WEST SUSSEX COUNTY COUNCIL CONSULTATION

TO:	Arun District Council FAO: David Spring
FROM:	WSCC - Highways Authority
DATE:	7 May 2020
LOCATION:	Land adjacent to Sefter School House, Sefter Road, Bognor Regis, PO21 3EE
SUBJECT:	P/116/19/OUT Outline application with all matters reserved for the erection of 4 No. semi-detached 3-bedroom houses & 2 No. detached 4-bedroom houses with associated access, parking & gardens. This application is a Departure from the Development Plan.
DATE OF SITE VISIT:	N/A
RECOMMENDATION:	Advice
S106 CONTRIBUTION TOTAL:	N/A

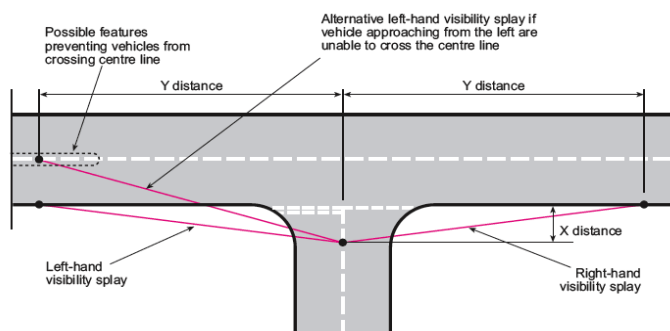
The applicant has not demonstrated maximum achievable visibility splays at either the existing or proposed access points. For the LHA to consider the suitability of a new access we would request these details to be provided.

All Visibility splays must include a 2.4m setback distance from the kerb edge of the footway and span in both directions to the kerbed edge. The splays must not intersect third party land, be located solely within land under the control of the applicant or within the Publicly Maintained Highway, and include the current road geometry. We have provided a diagram below for your guidance only.
